DPCR5 Methodology and Initial Results Paper

Response by Central Networks

Central
Networks

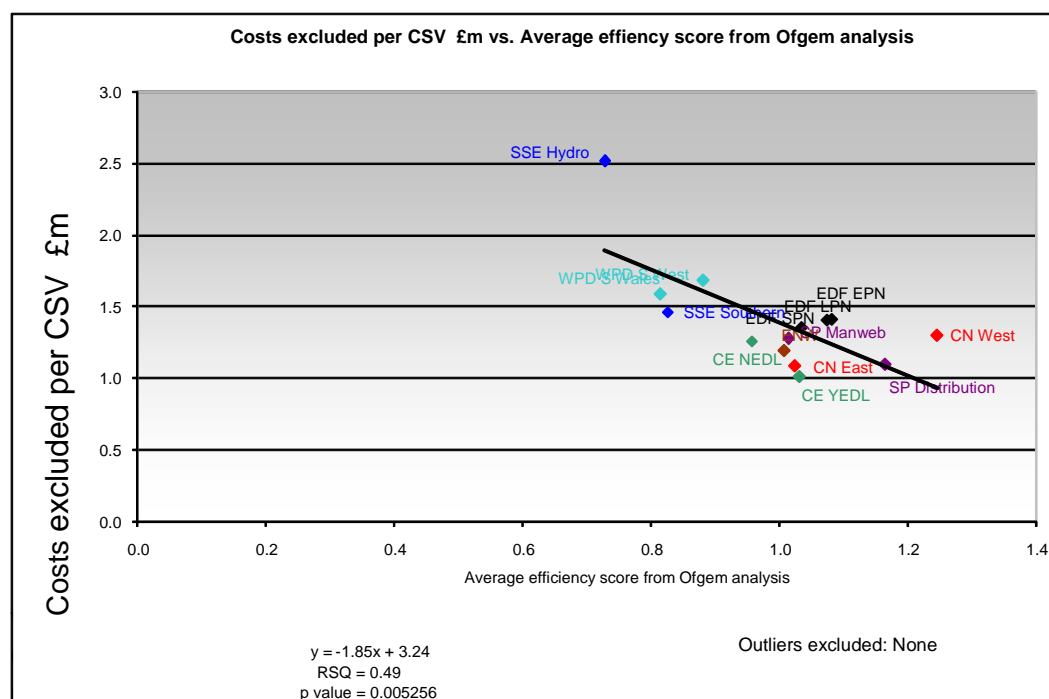
When comparing the results using either rankings or average efficiency rating it is clear that there is a relationship between the costs excluded and the overall result. (See below.)

While the R squared for this chart is relatively low this is partly due to the rankings limiting the x values to integer values.

The p value suggests that the hypothesis that there is no correlation between these values can be rejected with a confidence level of over 97%.

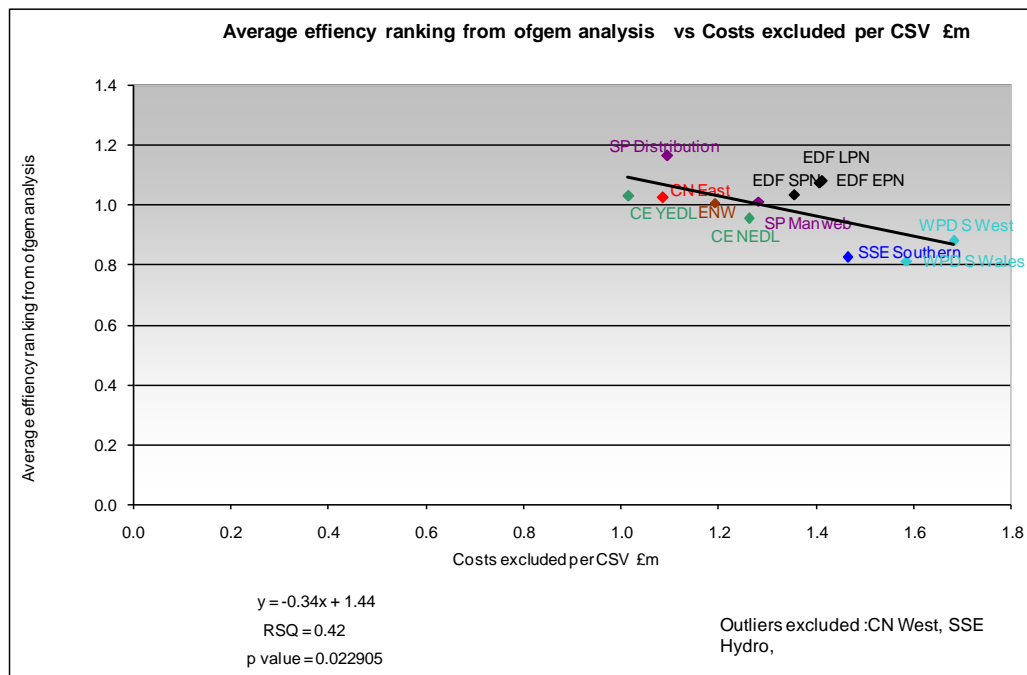
Using the actual efficiency score gives a stronger correlation and suggests that 49% of the difference in average efficiency score from Ofgem's analysis can be explained by the differences between DNOs in cost exclusions (graph normalised for scale).

of the efficiency result. For this reason, the chart below has been redrawn to show the efficiency score as the dependent variable.

This analysis demonstrates that the costs included or excluded from the analysis have a significant effect on the results obtained. This may be why the range of the results from Ofgem's benchmarking is wider than that put forward by Central Networks as the cost exclusions exaggerate the positions of both the DNOs that are considered more and less efficient.

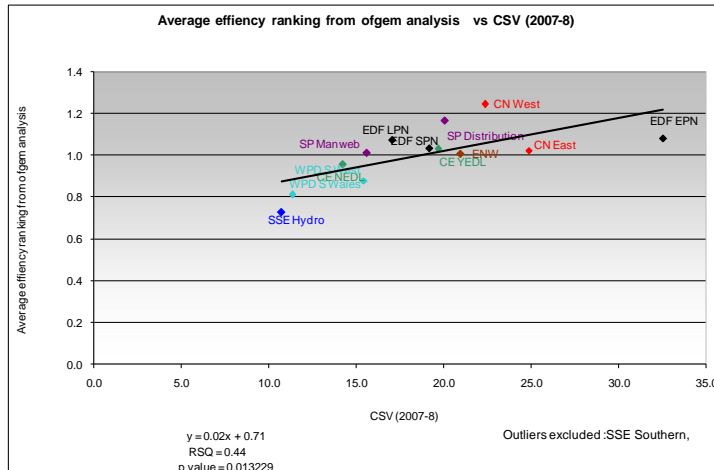
The shared modelling files for each activity show that the correlations between individual activities and drivers have low r^2 values. This is likely to be similar for the activity groups used in the bottom up benchmarking and are the building blocks of Ofgem's top down model. Many of the models fail the statistical tests as shown in table 11 of Appendix 5 which raises questions as to whether the cost models are acceptable.

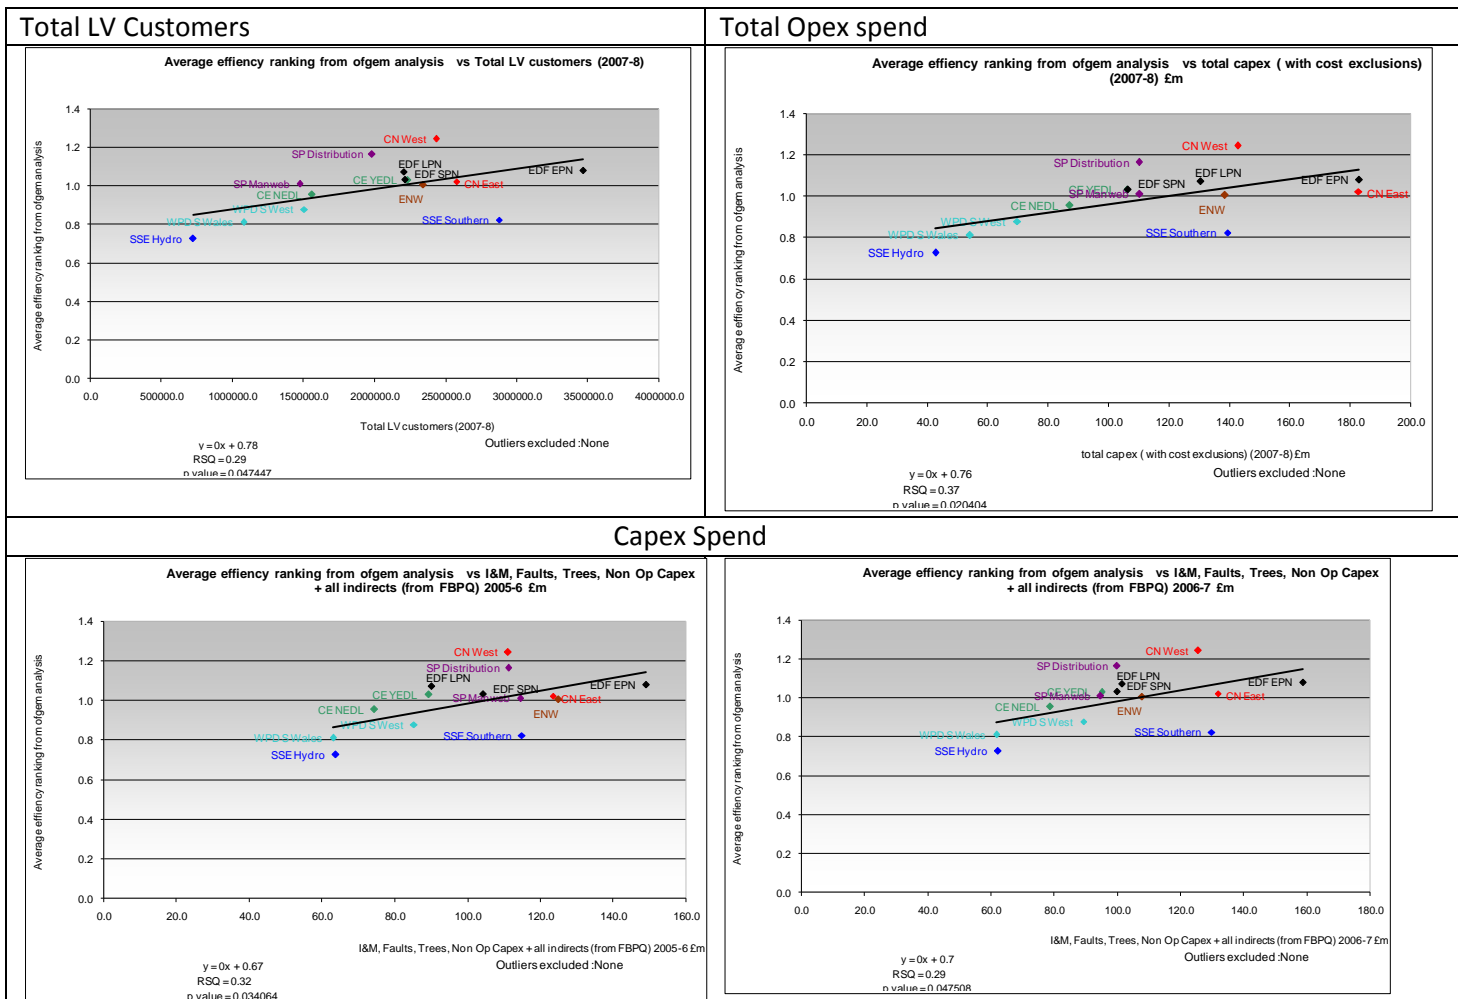
The average efficiency score is related to network scale expressed as CSV or in terms of number of customers, such that larger DNOs are more likely to have worse efficiency scores.

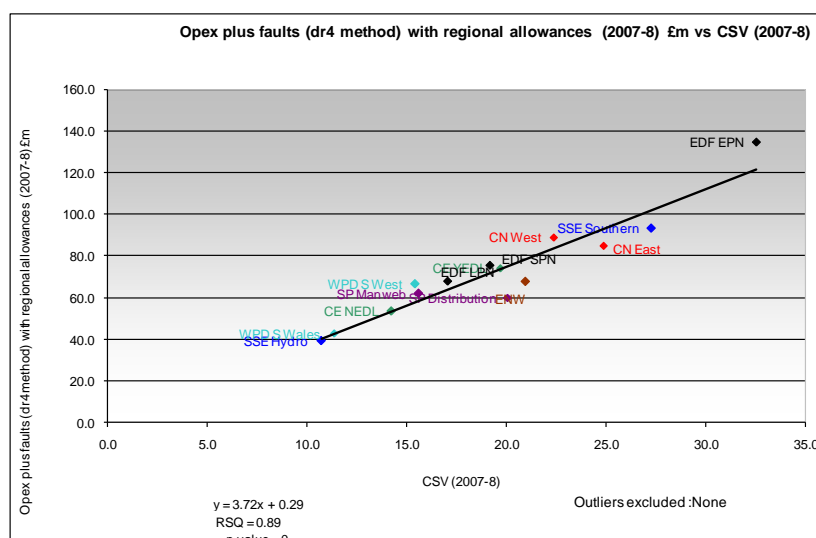
Similar relationships can be observed between the efficiency rankings and number of LV customers, Opex or Capex spend indicating bias in the cost model (next page).
